SUBJECT: HONEYWELL METROPOLIS WORKS RESPONSE TO RAIs FOR THE ENVIRONMENTAL REPORT

Enclosure 1 – Responses to RAIs on Section 9.1 Environmental Report of the MTW License Renewal Application

**Honeywell Metropolis Works
USNRC Source Materials License SUB-526
Docket No. 40-3392**

**License Renewal Application
Responses to Requests for Additional Information
Environmental Report**

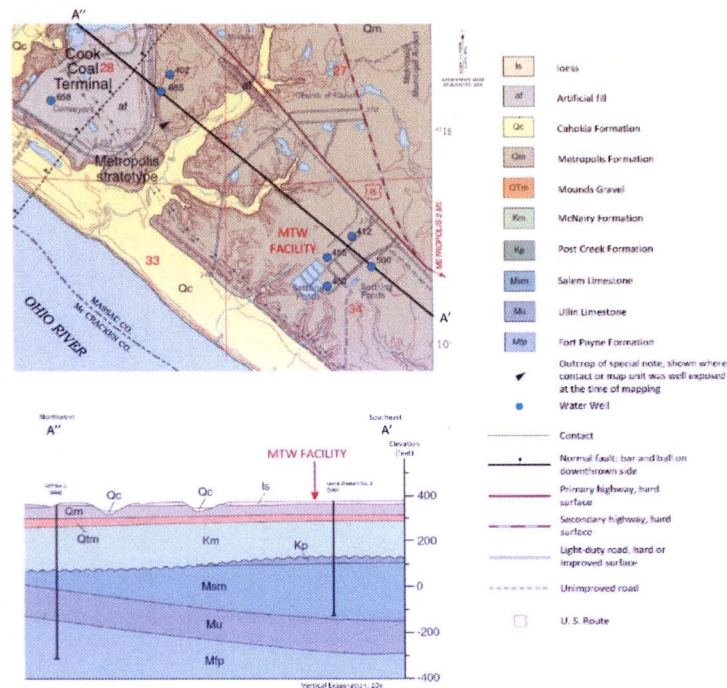
- A. ER Section 3.3.1, p. 3-8, makes no mention of the Metropolis or the Mounds Formations. However, both are clearly identified under the site as significant marker beds by the ISGS Joppa Quadrangle. Clarify the apparent inconsistency of the ER with the ISGS map.

- B. ER Section 3.3.1, p. 3-8, states that the first limestone is the St. Louis Formation. This is inconsistent with the name applied to that unit by the above-referenced ISGS Quadrangles. Clarify the apparent inconsistency of the names for the first limestone.

- C. ER Section 3.3.1, p. 3-9, states that “a sand deposit approximately 35 to 65 feet thick...” is “outwash from a distal valley train of the Mackinaw Member of the Henry Formation.” However, this is inconsistent with the name applied to that unit by the ISGS Quadrangles. The proper designation appears to be the Mounds Formation, which, as opposed to the Quaternary Henry Formation, is Tertiary in age sequence. Clarify why the unit is named Mackinaw in the ER as opposed to the Mounds Formation.

with the name applied to that unit by the ISGS Quadrangles. The proper designation appears to be the Metropolis Formation. Clarify if this unit should be called the Carmi Member of the Equality Formation or the Metropolis Formation.

Due to inconsistencies with the referenced report, Reference Honeywell 2015 will not be used. Geologic descriptions from the 2009 Environmental Assessment (NRC 2009) were compared to the 2008 ISGS Joppa Quadrangle (Nelson and Masters 2008) and the section has been revised to maintain consistency with the most current published geologic map. Figure 3.3-2 has been replaced with cross sections from the 2008 ISGS Joppa Quadrangle.
